PLANNING AND DEVELOPMENT SERVICES STAFF REPORT

For Planning Commission Meeting of June 18, 2013

**SUBJECT: Hampton Inn Planned Project Site Plan for City Council Approval
(2910 Jackson Avenue)
File No. SP13-002**

Date:	01.07.13
Scale:	1" = 40'
Sheet:	C-4
Project:	17485.01

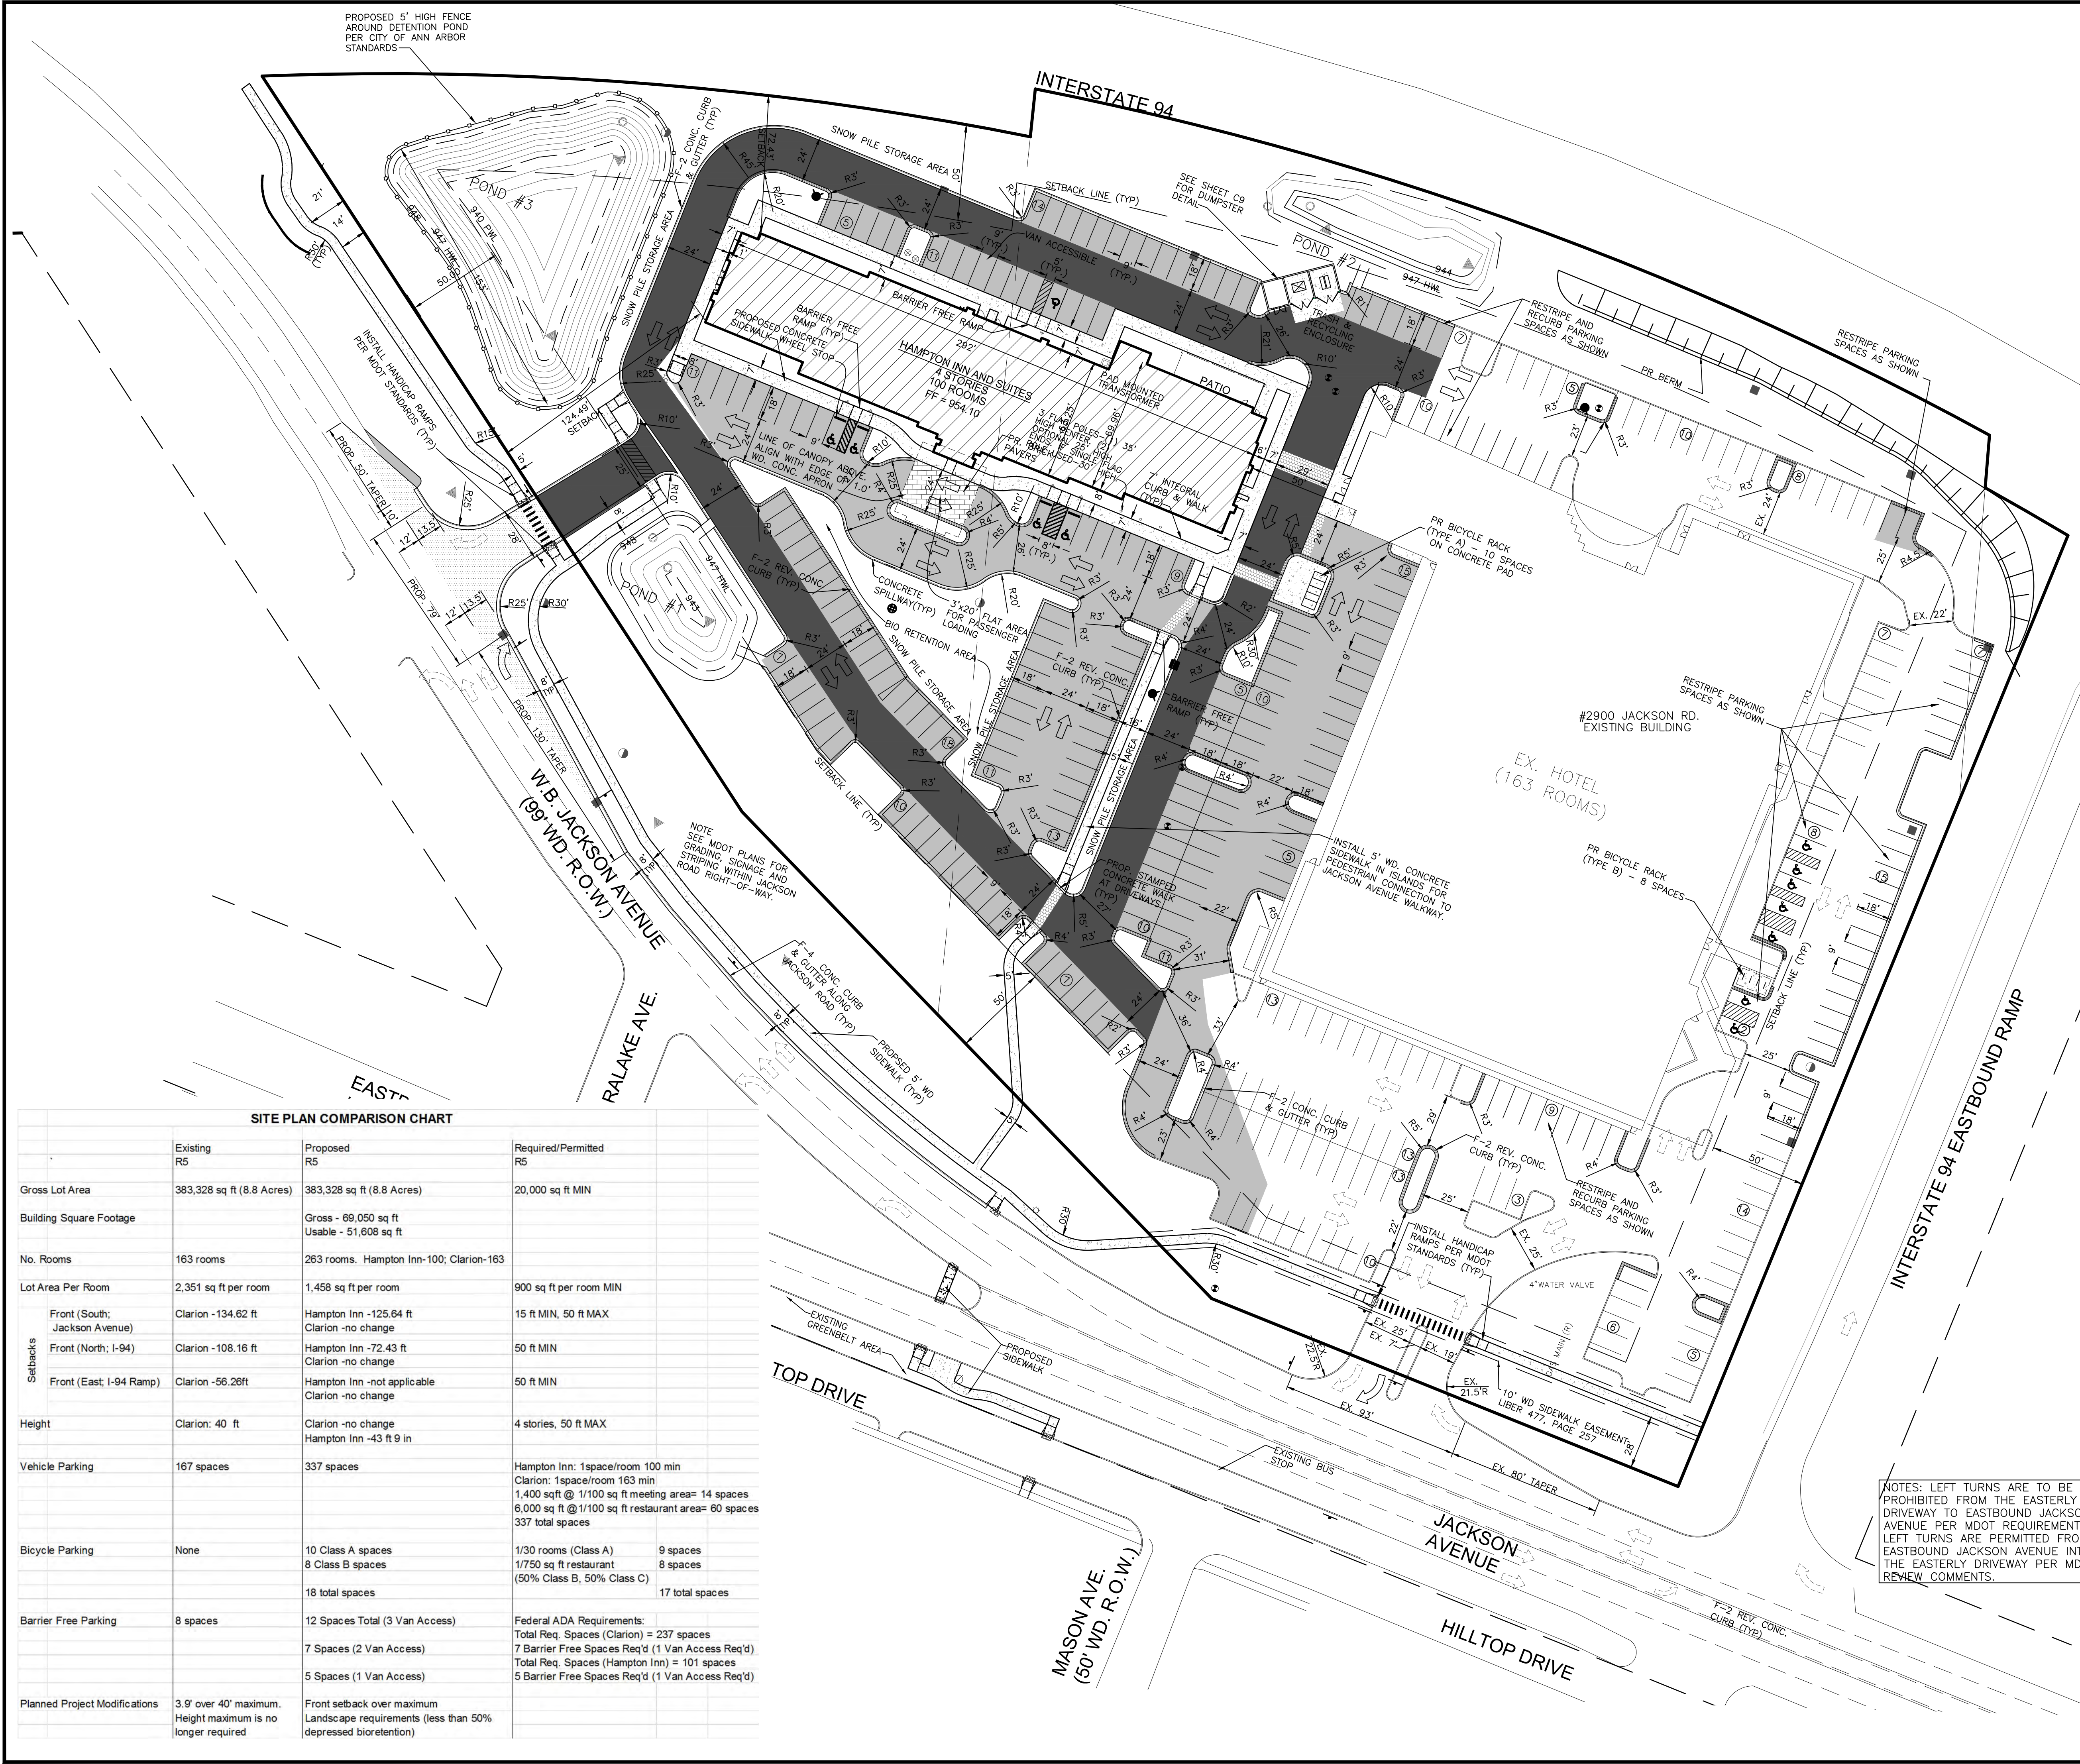
The petitioner is requesting a planned project modification to increase the maximum front setback requirement of 50 feet to allow a 72.4 foot setback from the north property line fronting I-94. When the foundation was poured in 2008, there was no maximum front setback requirement. Under recent amendments to the Zoning Ordinance, on a site with more than one front property line, only one is required to comply with the maximum front setback requirement. Since the existing foundation does not comply on any of the three fronts, a planned project modification is being requested. The petitioner indicates there is a public benefit provided by using existing infrastructure.

Planned project approval is requested to increase the maximum front setback requirement of 50 feet. The foundation poured in 2008 is 72.4 feet from the north property line facing I-94.

Staff recommends that the planned project site plan be **approved**, because the proposed building setback modification will result in a reduced need for infrastructure and, with the requested planned project modification, the contemplated development complies with applicable local, state and federal laws, ordinances, standards and regulations; limits the disturbance of natural features to the minimum necessary to allow a reasonable use of the land; and does not cause a public or private nuisance and does not have a detrimental effect on the public health, safety or welfare.
